ACCELERATED DISTRIBUTION DEMONSTRATION SYSTEM

SUBJECT: Application for amend to License DPR-74, revising Tech Specs
 re steam line break analysis.

Donald C. Cook Nuclear Plant Unit 2
Docket No. 50-316
License No. DPR-74
STEAM LINE BREAK ANALYSIS
TECHNICAL SPECIFICATION CHANGES

Reasons and 10 CFR 50.92
Significant Hazards Evaluation
for Changes to the
Technical Specifications for the
Donald C. Cook Nuclear Plant Unit 2

FIGURE 1

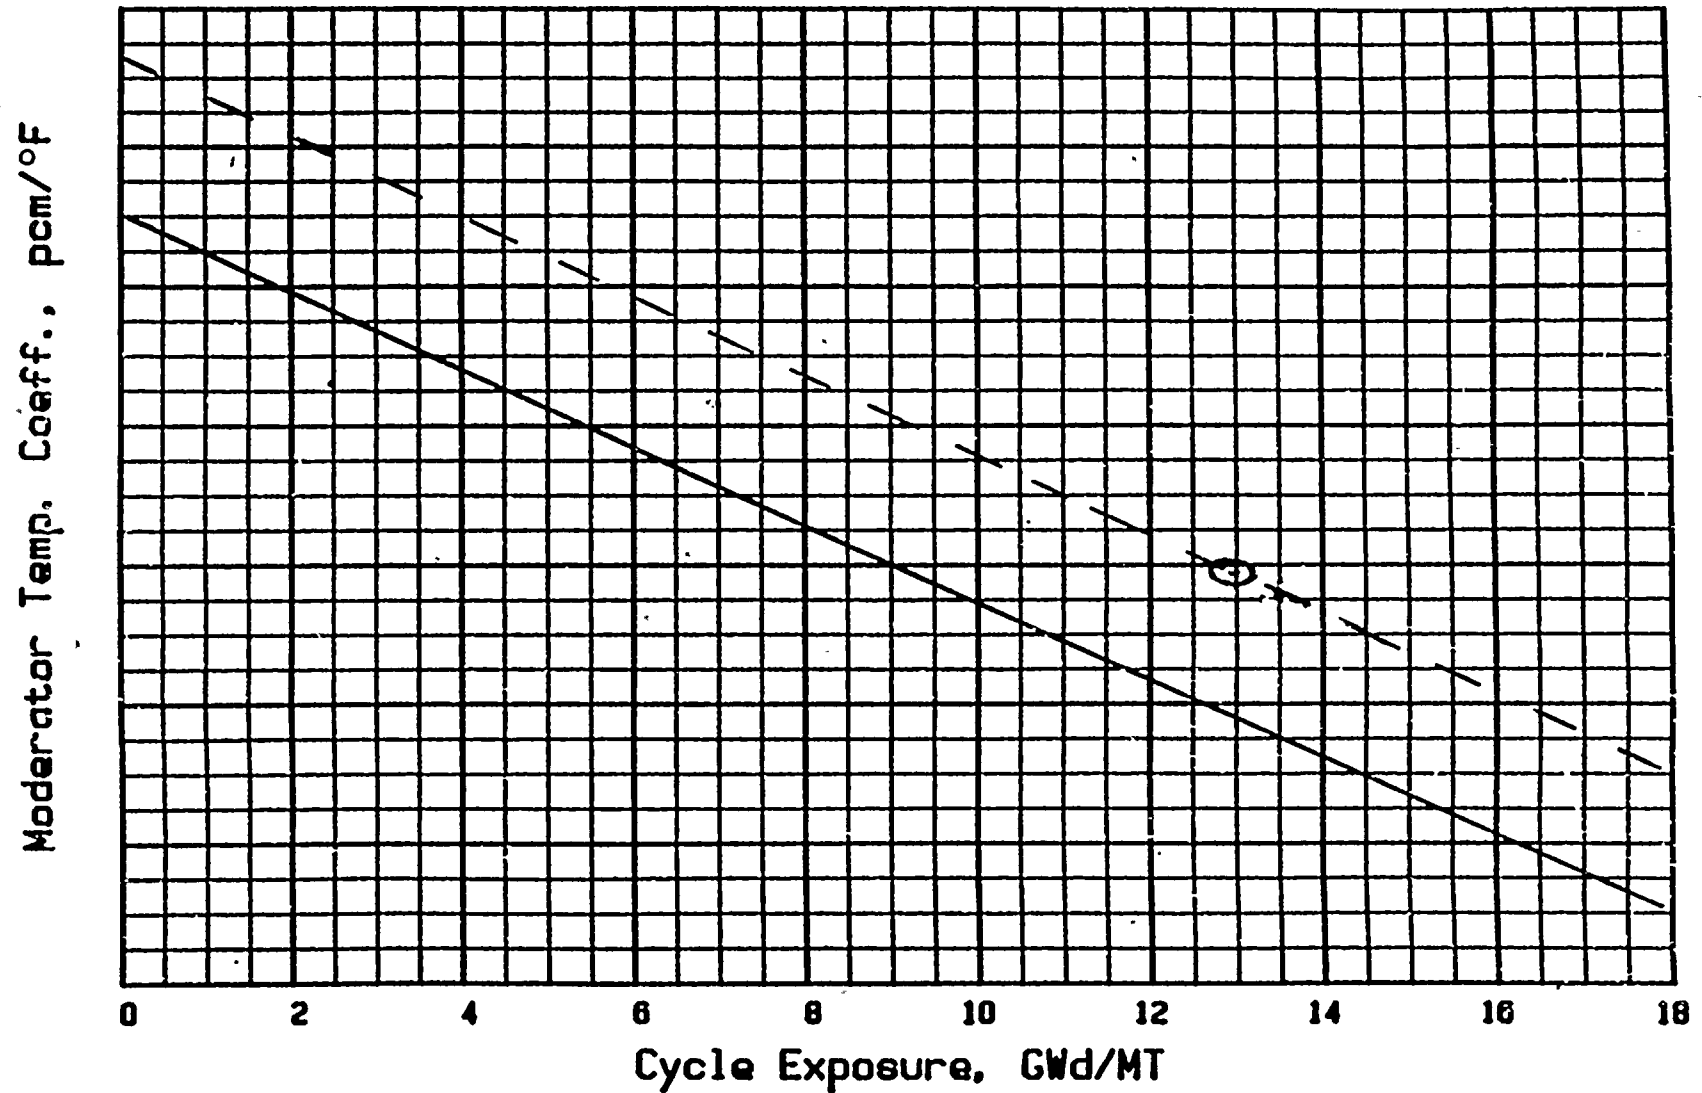
Extrapolation of the measured MTC at 300 ppm is achieved using cycle design data provided by the fuel vendor. The predicted MTC as a function of exposure is illustrated in Figure 1. (The curve is from Unit 2 Cycle 6). The 300 ppm measured value is extrapolated to the EOL exposure, using the same shape as the design curve.

As an example, the measured MTC for Unit 2 Cycle 6 was $-1.67 \times 10^{-4} \Delta k/k/^\circ F$ normalized to hot full power, all rods out, 300 ppm boron concentration conditions. Extrapolation of this data, as shown in Figure 1, yielded a predicted MTC value of $-2.23 \times 10^{-4} \Delta k/k/^\circ F$ at EOL. This value is compared to the limit of $-3.5 \times 10^{-4} \Delta k/k/^\circ F$. As can be seen, there is a substantial margin between the extrapolated MTC and the EOL limit.
